Model TC-131 Tape Controller Logic Manual

MODEL TC-131 TAPE CONTROLLER LOGIC MANUAL

P91000489

Rev. B

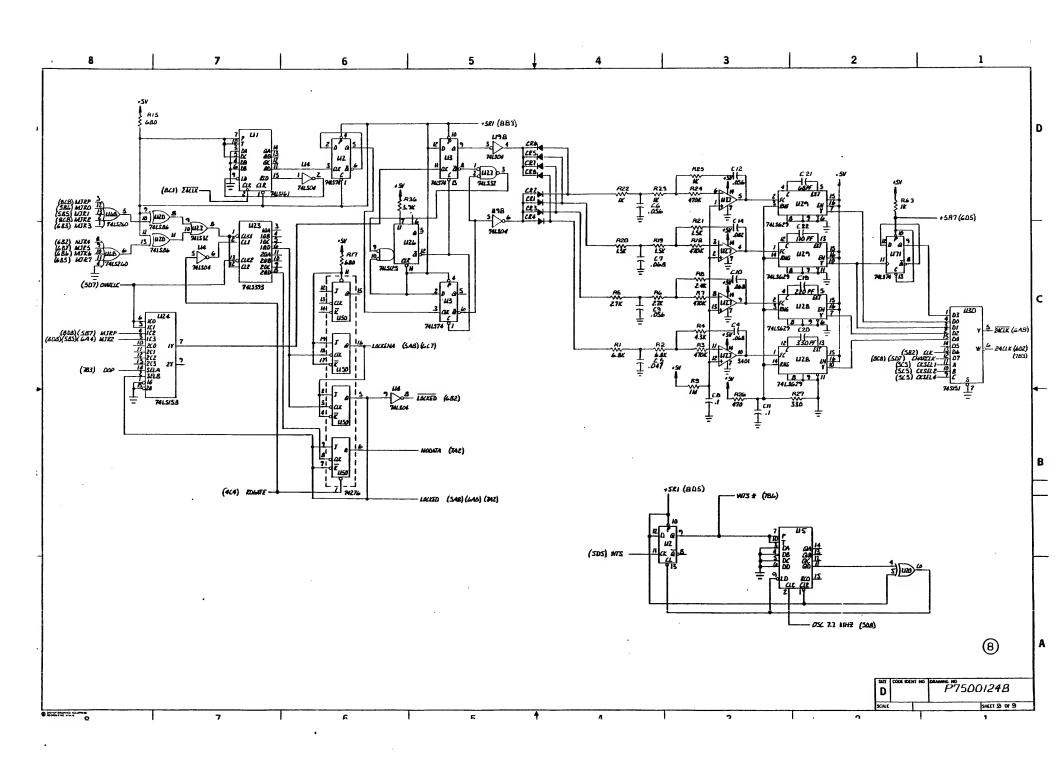
This configuration corrects a problem where NPG, BG and NPR are not propogated correctly.

- A. Label the spare location just below the LED's 1-5 as "S1".
- B. Label the second spare location below the LED's 1-5 as "S2".
- C. Install a 74LS14 I.C. in spare location S1 with pin 1 of I.C. in pin 1 of the printed circuit board.
- D. Install the following components in spare location "S2":

COMPONENT	VALUE	LOCATION
P14000335	270 Resistor	S2-2 to S2-15
P15000102	82 PF Capacitor	\$2-3 to \$2-14
P14000335	270 Resistor	S2-7 to S2-10
P15000102	82 PF Capacitor	S2-8 to S2-9

E. Lift pins:

U76-9, U76-10, U49-9, U49-10.

F. Add Jumpers:

FROM	<u>T0</u>	<u>T0</u>
U73-6	S2-2	
U73-8	S2-7	
S2-3	s2-8	
S2-9	S2-10	S1 - 13
S2-14	S2-15	S1-1
S1-2	S1-3	•
S1-4	U76-9	U76-10
S1-12	S1-11	
S1-10	U49-9	U49-10
S1-7	(\$1-8)	Pad on P.C.B. GND

TOLFRANCES UN OTHERWISE SPE FRACTIONS DE	CIFIED	₩¢	stern p	eripheral:	TM STIN, CALIFORNIA
± ±	±	MODIFIC TAPE CO	TAC	ION	DWG-
APPROVALS	DATE				D 54.47/01
DRAWN [])	10-1-80	TAPE CO	NT. A	NAPIE	R, CONF 5
CHECKED Lantich				DRAWING N	
H. Cantach	10-2-20		В	1120	001
		DO NOT SCA	LE DRA	WING	SHEET LOF !

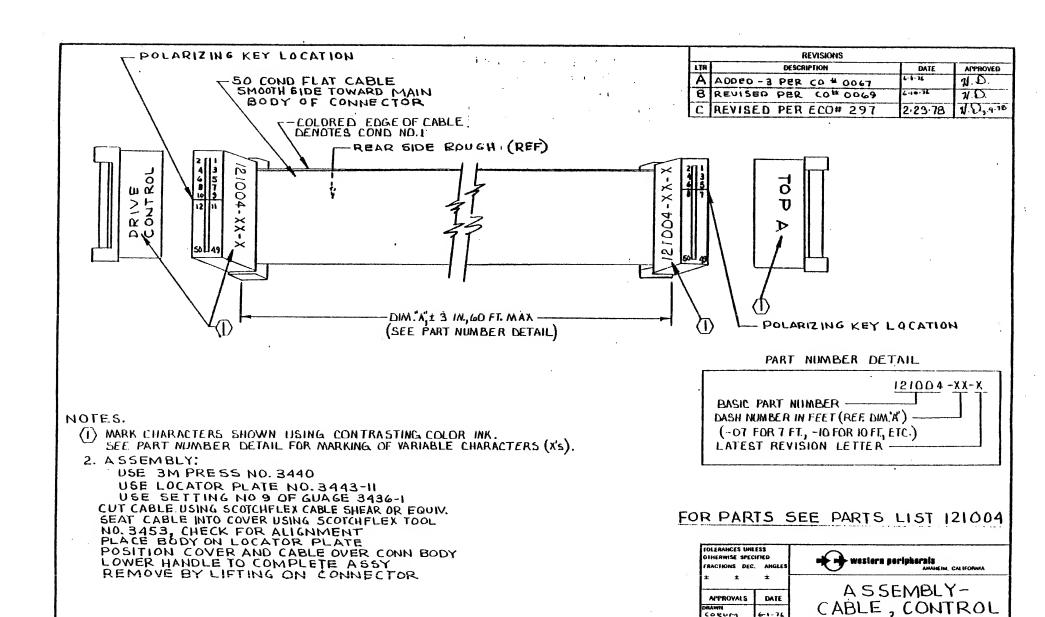
SHEET (2) OF SCHEMATIC 122036 IS ALTERED AS OUTLINED BELOW!

REWORK INSTRUCTIONS: FOR ASSY 122037, 122038, 122039

- A). CUT ETCH 2 PLCS AT C-8 (SOLDER SIDE)
- B), ADD JUMPER FROM C-10 TO FEED-THRU ON ETCH THAT WAS CONNECTED TO C-8
- C) IDENTIFY AT ASSY NO. WITH "CONF 5" USING BLACK INK.
